RE: Silver Leaf revision

# PUD CONCEPTUAL PLAN FOR **SILVER LEAF** PLANNED UNIT DEVELOPMENT CITY OF DES MOINES, POLK COUNTY, IOWA

**AMENDED PUD CONCEPTUAL PLAN**  
**SILVER LEAF**  
**SNYDER & ASSOCIATES**  
2727 S.W. SNYDER BLVD.  
MAYNARD, IOWA 52233  
515-664-7025

**APPROVAL** of a request from Savannah Homes, Inc. represented by Ted Grob (officer), Central Iowa Developers, LC (owners) to be found in conformance with the existing Des Moines' 2020 Community Character Plan and amend the Silver Leaf PUD Conceptual Plan for property located at 5100 NE 28<sup>th</sup> Avenue to allow reconfiguration of the street, alley, and lot layout, including an increase in the number of lots from 131 to 158 subject to the following conditions: (ZON2008-00130)

Sheet 1 of 3  
108-0284A  
59

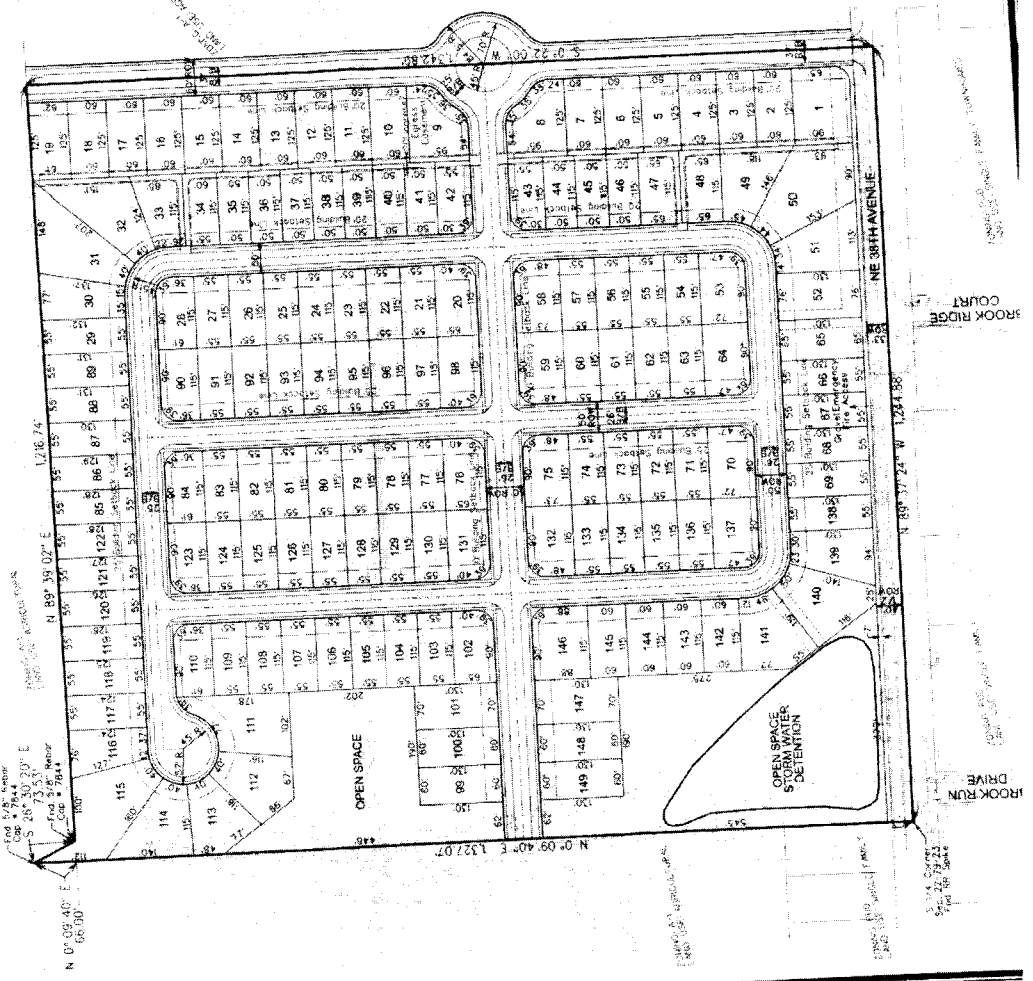
- Addition of a note to sheet stating that each building/owner is responsible for lot maintenance, erosion control and adhering to all EPA and DNR standards.
- One additional tree per two lots, which means 1 street tree per lot and 75 additional trees throughout the development.
- Provision of a temporary turnaround for emergency apparatus on the north end of the north/south collector street.
- The northernmost east/west street shall have a 26-foot back to back paved width.
- Inclusion of a statement describing how a second public street connection to NE 38th Street Avenue would be achieved in the future to accommodate development of land adjoining to the west.
- Revise the emergency fire access drive to indicate its width (min. 20 feet) and that it have a dustless surface (not gravel) such as recycled asphalt product.

7. Each single-family dwelling unit with street loaded access shall have a private garage, whether attached or detached. Lots 1-19 and 32-49 on the PUD concept may have an optional garage.

8. The roof on any home constructed shall be of architectural type shingles or cedar shakes. Note #10 shall be revised to remove the ability to have standard asphalt shingles.

9. Remove the provision in note #11 (f) allowing review by the Zoning Board of Adjustment.
10. Clarification on sheet 1 of 3 of the Concept Plan that 40' of right-of-way will be dedicated along Douglas Avenue (NE 38<sup>th</sup> Avenue).

11. Clarification on sheet 1 of 3 of the Concept Plan that the 2020 Community Character Land Use designations for the subject property are Low Density Residential and Low/Medium Density Residential.

12. Revision of the bulk regulations regarding rear loaded lots to reference only Lots 32-49 and Lots 8-9 (if not paired housing).
